City of Waltham
Purchasing Department
Waltham, Massachusetts 02452
ADDENDUM NO. 2
March 20th, 2019

Plans & Specifications for: **Bobby Connors Playground Improvements, Waltham, MA**

This Addendum No. 2 is to modify, correct and/or supplement the Plans and Specifications.

DWG No. **L.1**

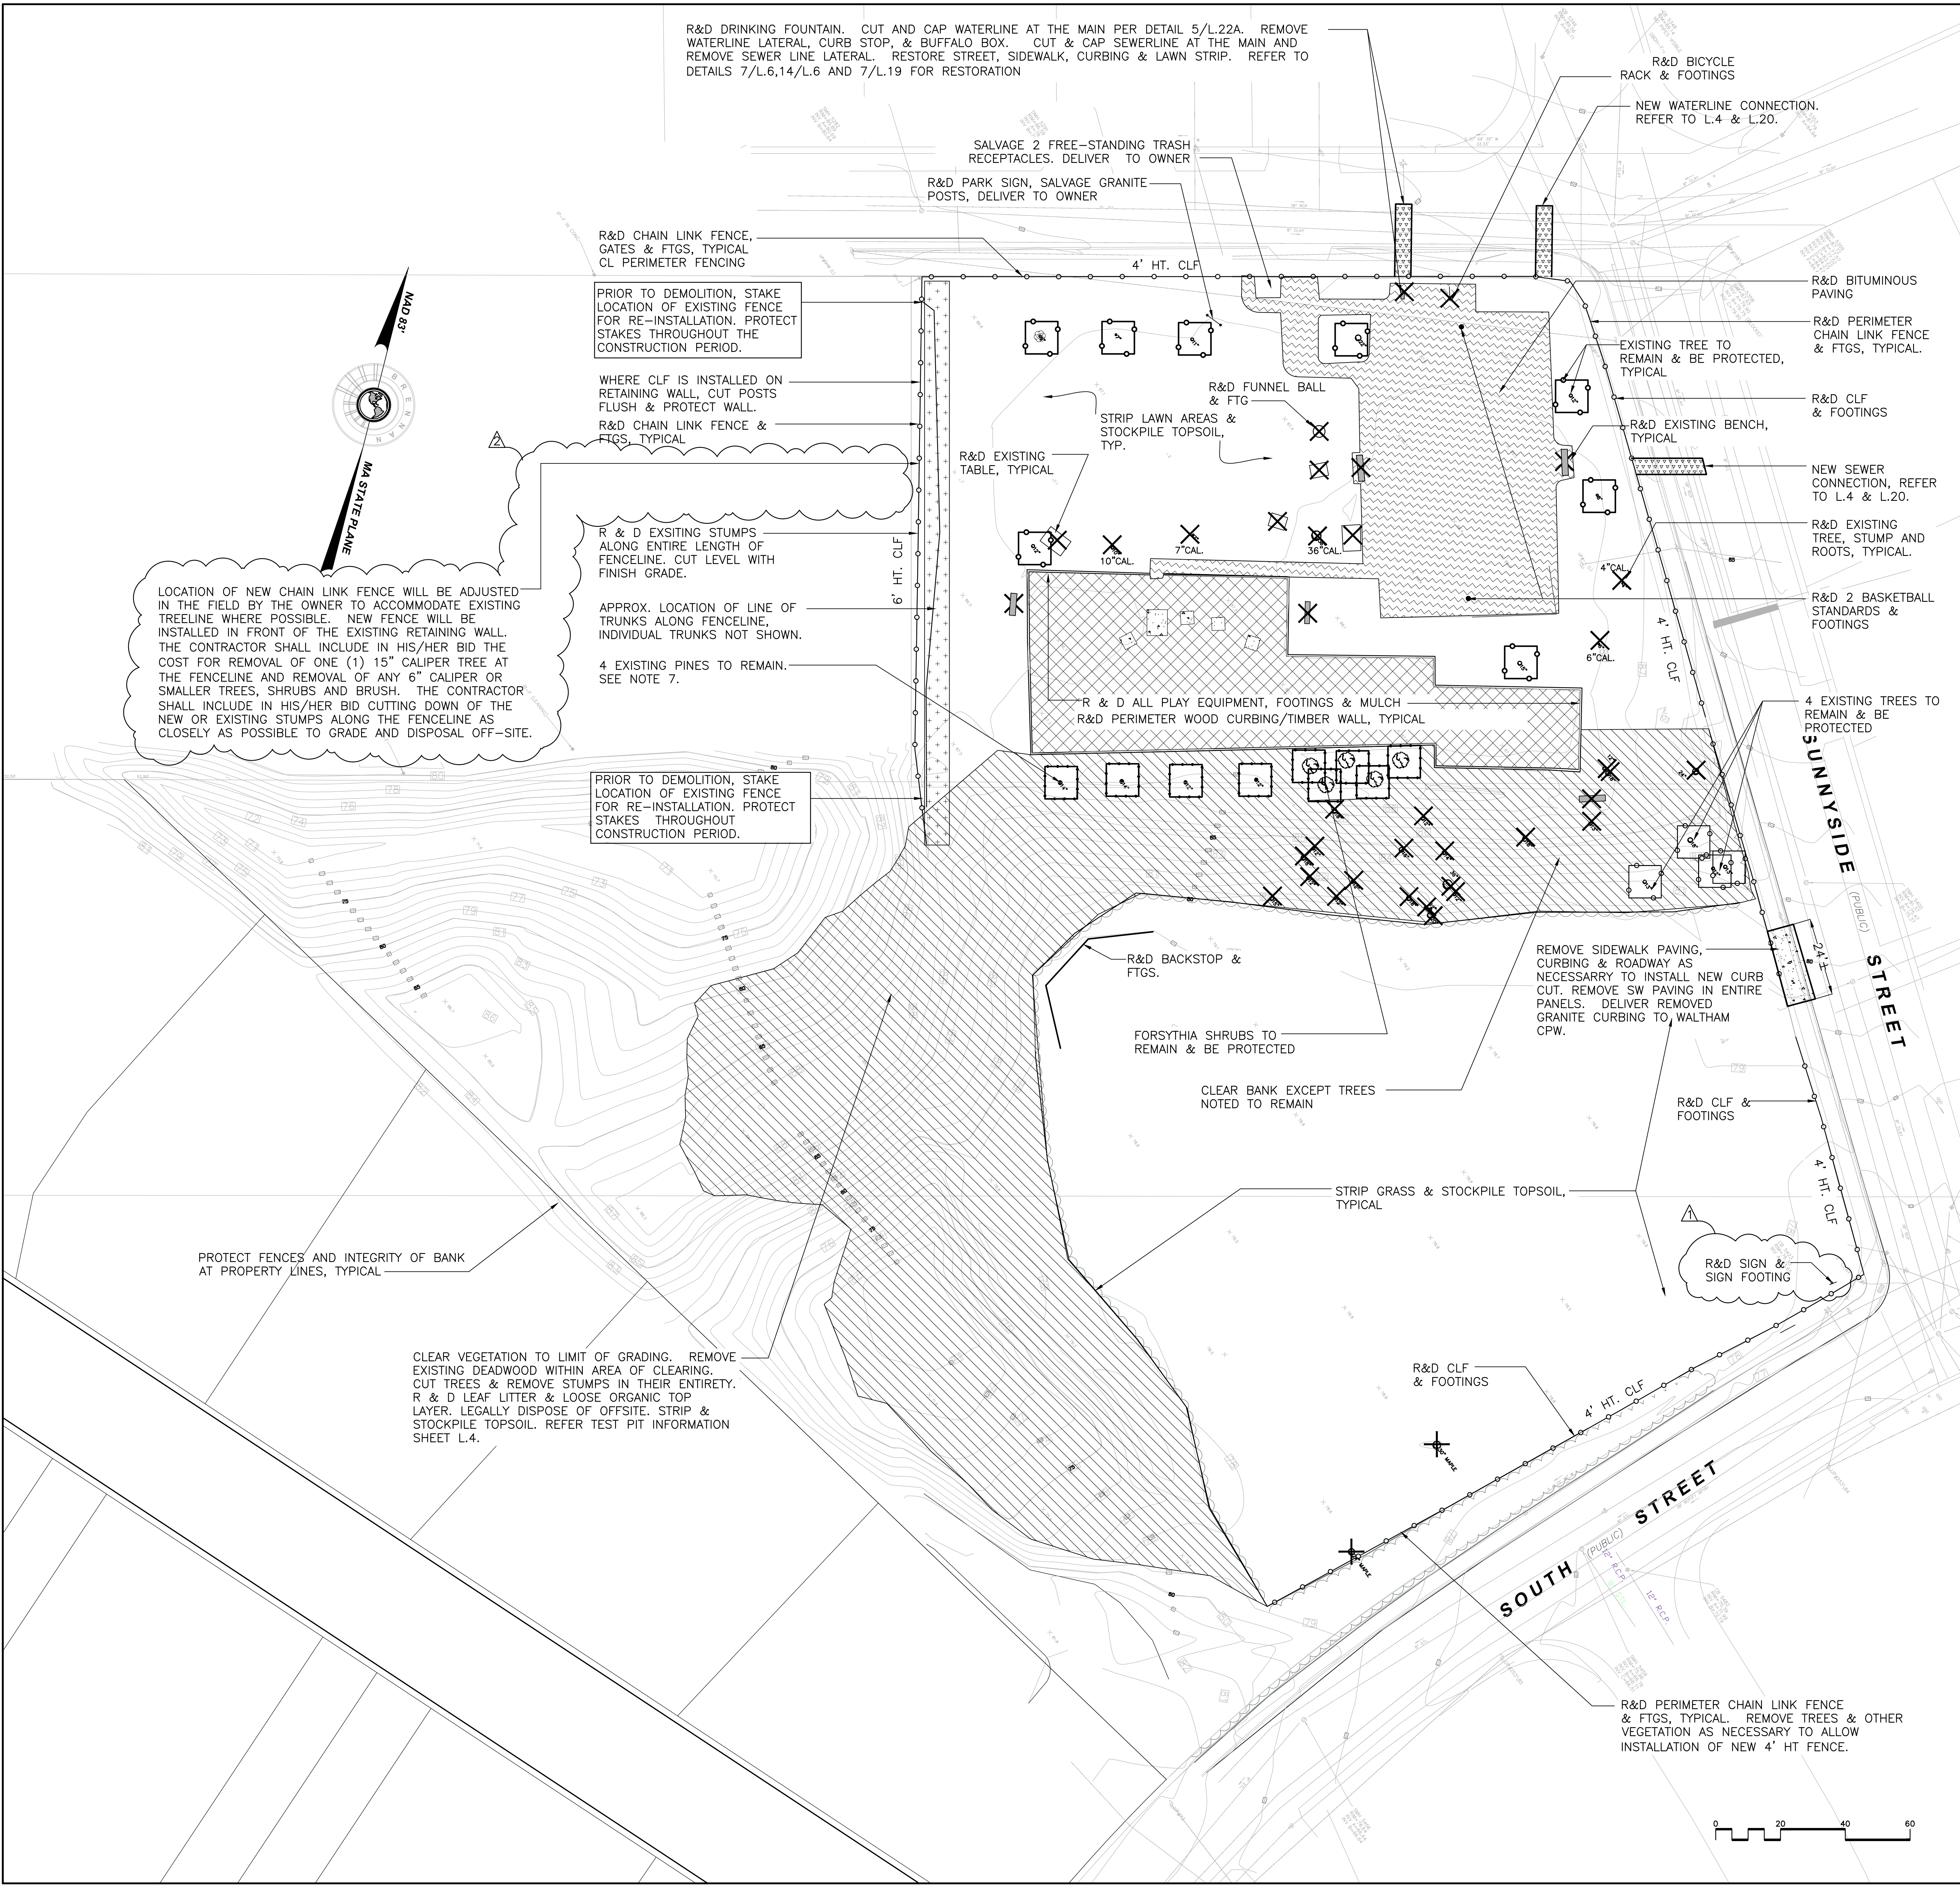
ITEM NO. 7 Revision to Drawing L.1 Site Preparation

Add Note:

“R&D Single Post Sign and Sign Footing” at location shown on revised L.1 attached.

Delete note from L.1:

“Remove trees and other vegetation as necessary to allow installation of new 6’ ht fence”.

Replace with note:

“Location of new chain link fence will be adjusted in the field by the Owner to accommodate existing tree line as closely as possible. New fence will be installed in front of the existing retaining wall. The Contractor shall include in his/her bid the cost for removal of one (1) 15” diameter tree at the fence line, and removal of any 6” caliper or less trees, shrubs and brush. The Contractor shall include in his/her bid cutting down of the new or existing stumps along the fence line as closely as possible to grade, and disposal off-site.”
